# UNITED STATES PATENT AND TRADEMARK OFFICE

APPLICATION NO.	FILING DATE	FIRST NAMED INVENTOR	ATTORNEY DOCKET NO.	CONFIRMATION NO.
10/775,119	02/11/2004	Michael Geren Farrell	A8381	1265

This is the second office action for application number 10/775,119, Pipe and Cable Support Apparatus and Method, filed on February 11, 2004.

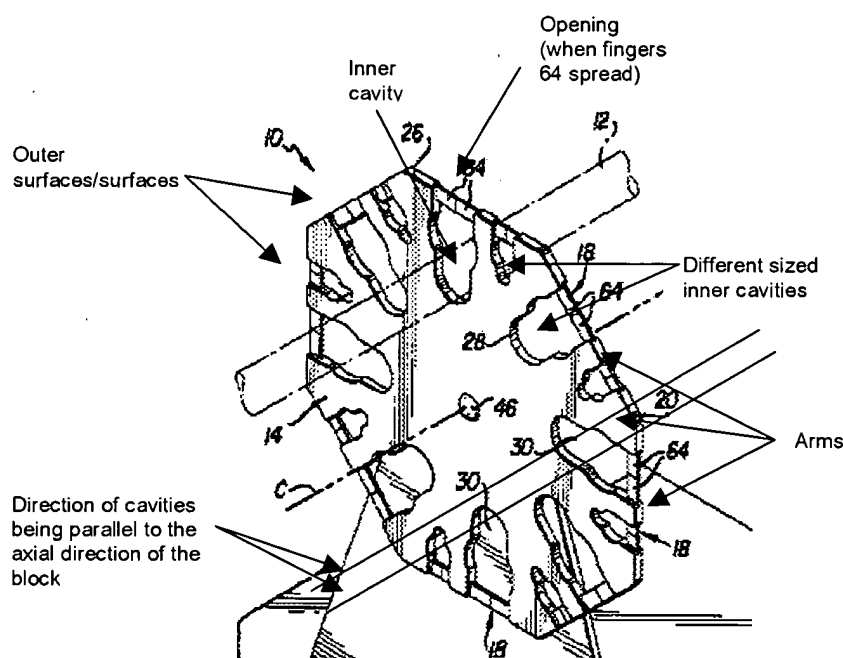
Claims 1-4, 12, 21, 22, 26 and 27 are rejected under 35 U.S.C. 102(b) as being anticipated by U.S. Patent number 6,375,017 to Schattner et al.

Schattner et al. '017 a support apparatus/block member (figure 1) comprising a plurality of outer surfaces/surfaces (above), an opening (above) disposed at at least one outer surface, and an inner cavity (above) being disposed inward from the opening, wherein each of the plurality of outer surfaces includes a corresponding opening and a corresponding inner cavity, wherein the corresponding inner cavities for the plurality of outer surfaces have different sizes, wherein the

support apparatus further comprising a plurality of openings in at least one of the outer surfaces, wherein the opening inherently could have a width less than the nominal diameter of at least one of a pipe and cable and the cavity cross sectional area, wherein the support apparatus includes an axial direction (along C) and a radial direction substantially radially perpendicular to the axial direction, wherein the apparatus has a plurality of projecting arms (above) extending substantially in the radial direction wherein two adjacent arms inherently could cooperatively support that at least one of the pipe and cable thereinbetween, wherein the adjacent arms cooperatively form a cavity and the distal ends of the arms form an opening into the cavity and wherein the cavity could inherently be larger than a nominal diameter of a pipe or cable, wherein one of the plural surfaces includes a plurality of openings leading to cavities, wherein the openings and corresponding cavities are of varying sizes, wherein the block is formed of plastic (column 5, lines 61-63), wherein all cavities are parallel to an axial direction of the block (see above), wherein the block/apparatus could perform all recited functions.

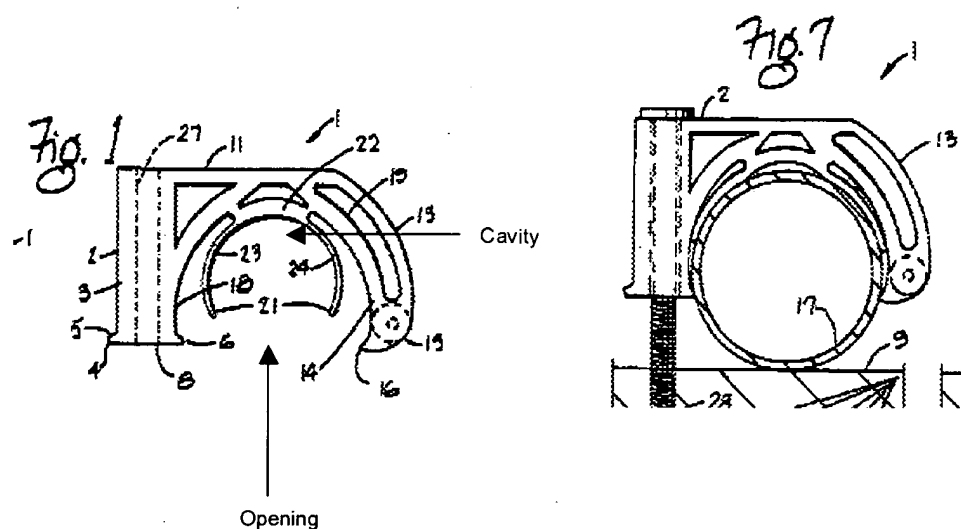
Claim 28 is rejected under 35 U.S.C. 103(a) as being unpatentable over Schattner et al.

'017.

Schattner et al. '017 teaches the previous invention wherein the block is formed of plastic, but fails to specifically reveal the block to be formed of an *extrudable* plastic. It would have been obvious to one of ordinary skill in the art at the time the invention was made to have formed the block of *extrudable* plastic since it is a well-known process in the art for forming plastic devices.
